POLICY REPORT
DEVELOPMENT AND BUILDING

SUBJECT: CD-1 Rezoning: 508 West 28th Avenue and 4439-4461 Cambie Street

Site Plan

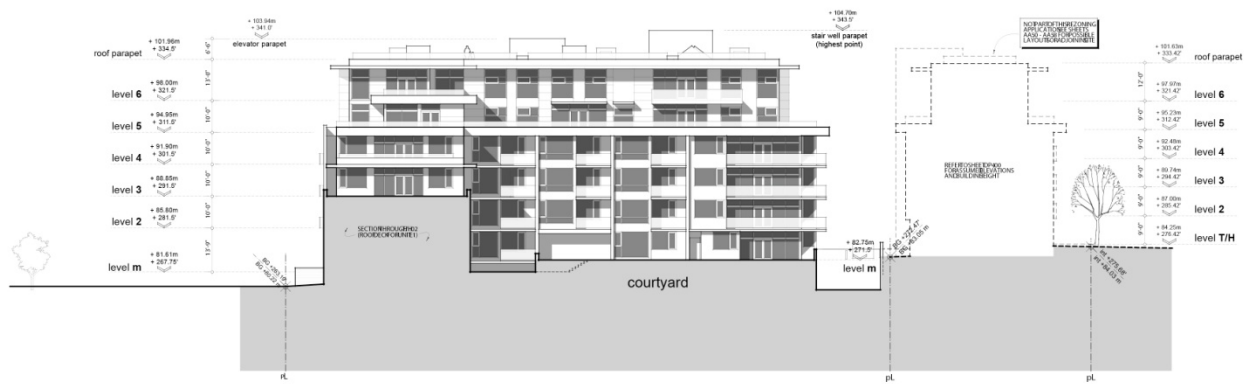
- 1. Design development to reduce the building massing along 28th Avenue by removing or reducing by a measure of approximately 6 m (20 ft.) that westerly portion of Unit "E1" located on level 3.

- 2. Design development to revise the townhouse massing along the lane to adhere to the following criteria:
 - (a) consolidate the laneway townhouse blocks into a single building with a building length not to exceed 25 m (82 ft.);
 - (b) increase the setback between the townhouse building and the ramp to support access and service of the courtyard space;
 - (c) increase the setback between the townhouse building and the two-storey portion of the main building; and
 - (d) increase the setback between the townhouse building and the property line at the lane in order to provide for enhanced landscape opportunities contributing to the lane environment.

- a. Modify the parking ramp to start from the PL and to have a maximum slope of 12.5% after the first 20 ft. from the PL.

- c. Provision of an improved section drawing A3.00 of the ramp showing as minimum 2.3 m of vertical clearance and note on plans.
- d. Clarification is required that the parking access ramp retaining walls do not encroach over the west property line as appears to be indicated on page A2.04.
